Submit 1 Copy To Appropriate District Office District 1 – (575) 393-6161 State of New Mexico HOBBEnergy, Minerals and Natural Resources	Form C-103 October 13, 2009
1625 N French Dr. Hobbs NM 88240	WELL API NO.
District II – (575) 748-1283 811 S. First St., Artesia, NM 88210 JUN 1012 CONSERVATION DIVISION	3002510673       5. Indicate Type of Lease
District III – (505) 334-6178 1220 South St. Francis Dr.	STATE FEE
1000 Rio Brazos Rd., Aztec, NM 87410 District IV – (505) 476-3460 <b>RECEIVED</b> Santa Fe, NM 87505	6. State Oil & Gas Lease No.
1220 S. St. Francis Dr., Santa Fe, NM 87505	301940
SUNDRY NOTICES AND REPORTS ON WELLS (DO NOT USE THIS FORM FOR PROPOSALS TO DRILL OR TO DEEPEN OR PLUG BACK TO A DIFFERENT RESERVOIR. USE "APPLICATION FOR PERMIT" (FORM C-101) FOR SUCH PROPOSALS.)	<ul> <li>7. Lease Name or Unit Agreement Name</li> <li>SKELLY PENROSE B UNIT</li> <li>8. Well Number 056</li> </ul>

11. Elevation (Show whether DR, RKB, RT, GR, etc.)	
12. Check Appropriate Box to Indicate Nature of Notice, Report or Other Data	
NOTICE OF INTENTION TO: SUBSEQUENT REPORT OF:	
PERFORM REMEDIAL WORK 📋 PLUG AND ABANDON 🛛 REMEDIAL WORK 🔲 ALTERING CASING	
TEMPORARILY ABANDON CHANGE PLANS COMM

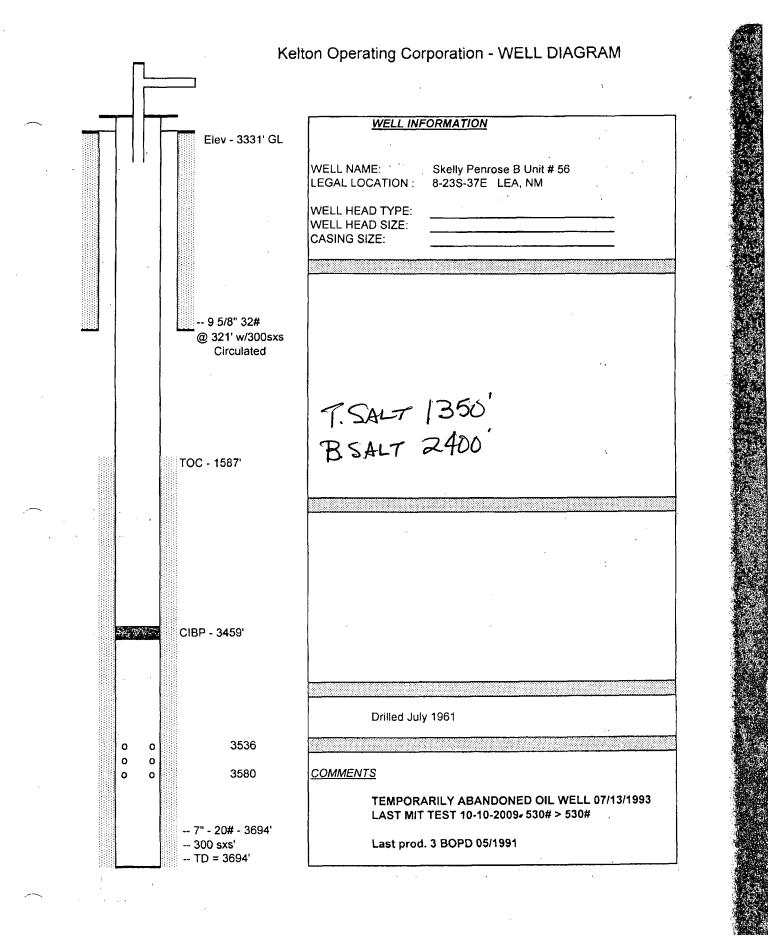
IF This well in R5003 and. Cement required across entire salt section	
Spud Date: Rig Release Date:	
I hereby certify that the information above is true and complete to the best of my knowledge	e and belief.
SIGNATURE CLARK TITLE RESIDENT DATE 6-11-13	
Type or print name CDALE KELTON E-mail address: PHONE:	
APPROVED BY: Arm TITLE DIST. MAR DATE 6-15-2013 Conditions of Approval (If any):	
Oil Conservation Division - Hobbs office: Must be Notified	r Forms On-A-Disk · (214) 340-9429 · FormsOnADisk.com
24 hours prior to the beginning of Plugging Operations begin.	JUN 1 3 2013 7000
